PANEL ASSESSMENT OF INTERSTATE BRIDGES SEISMIC VULNERABILITIES

Draft Technical Report

December 18, 2006

Figure 4-1. Foundation and Pier Retrofit Alternative 1

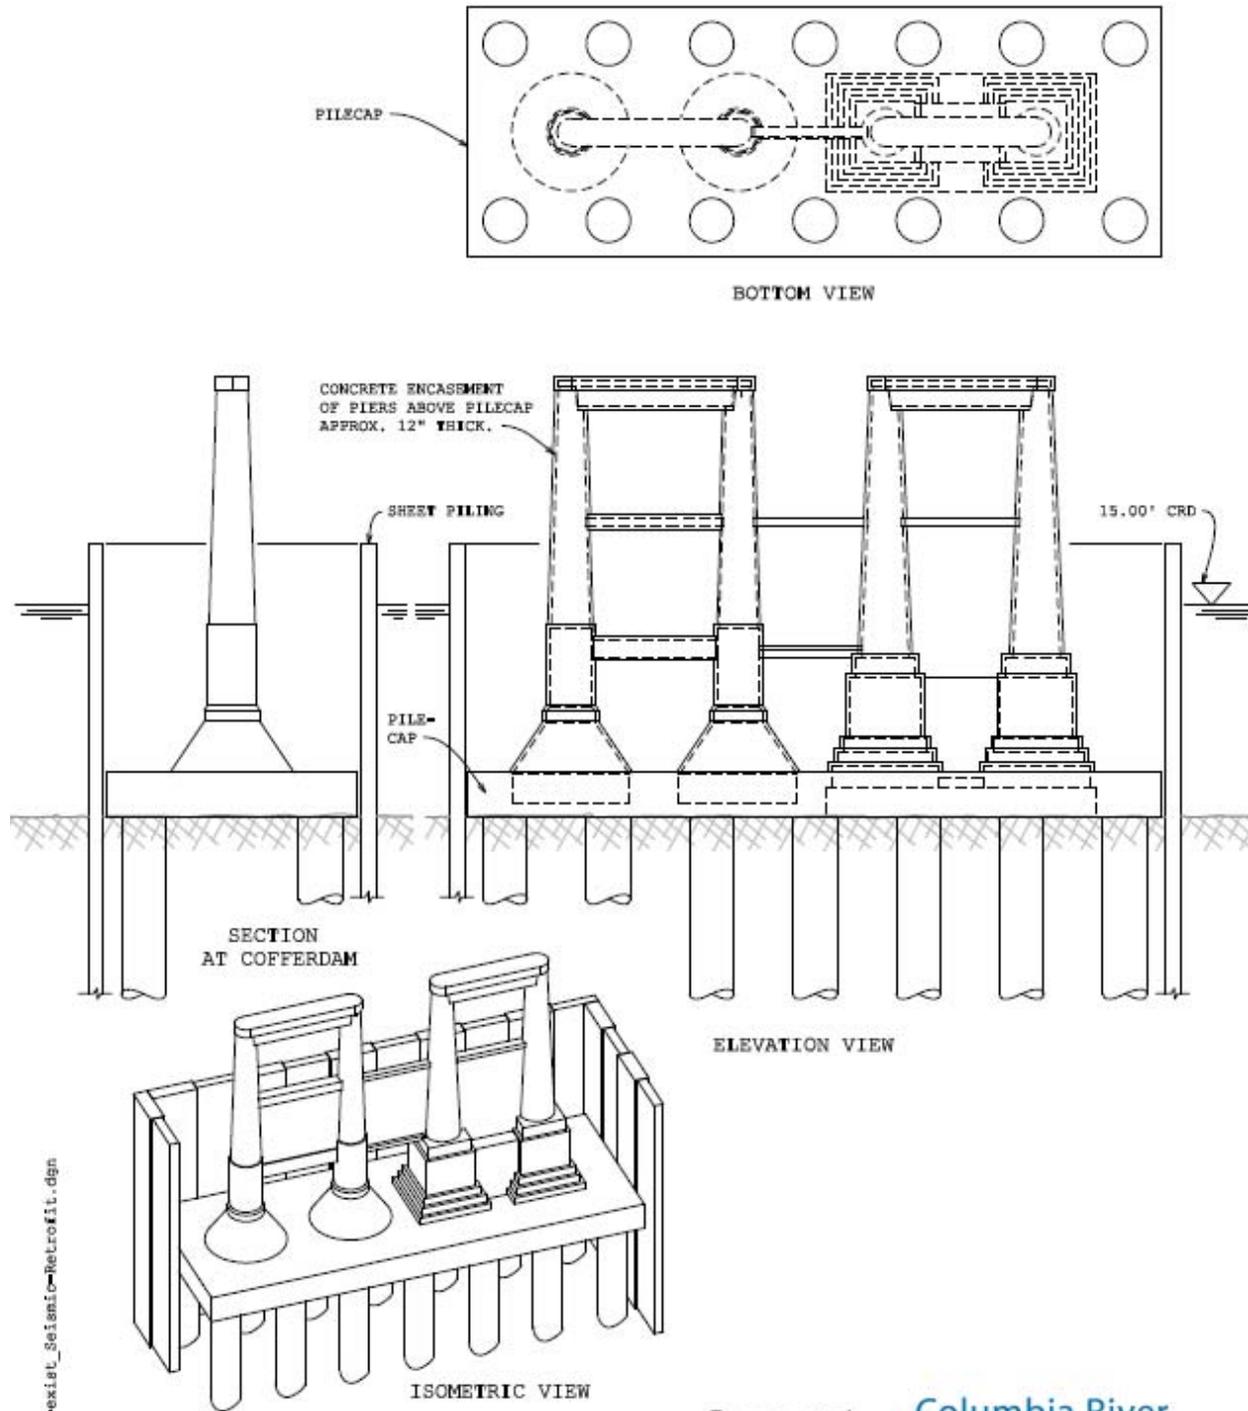
Foundation and Pier Retrofit: The foundations will comprise the largest element and cost of the retrofit. Two alternatives were considered: one that retrofits the foundations at the pile cap level and below and one that constructs a new pile cap at or above the water level. For costing purposes, both options assumed pile groups that consist of large (8 feet to 12 feet) diameter shafts around each pier, and that the piles would be up to 200 feet long, reaching far below the liquefaction layers and to or nearly to the Troutdale formation (rock).

Having the new pile cap at or above the water level could eliminate the need for cofferdams. The lower range of values reflects this alternative. The higher-end costs include a cofferdam and work below the water line.

For the retrofit of the piers, primarily to provide additional ductility, the concept assumes that #8 welded hoops are placed at 6-inch spacing along the entire face of the pier. This includes drilling through the in-fill walls between the columns and running the hoops through the drilled holes. The entire pier would then be encased in a shotcrete jacket either 6 inches or 12 inches thick. These concepts are shown in Figures 4-1 and 4-2.
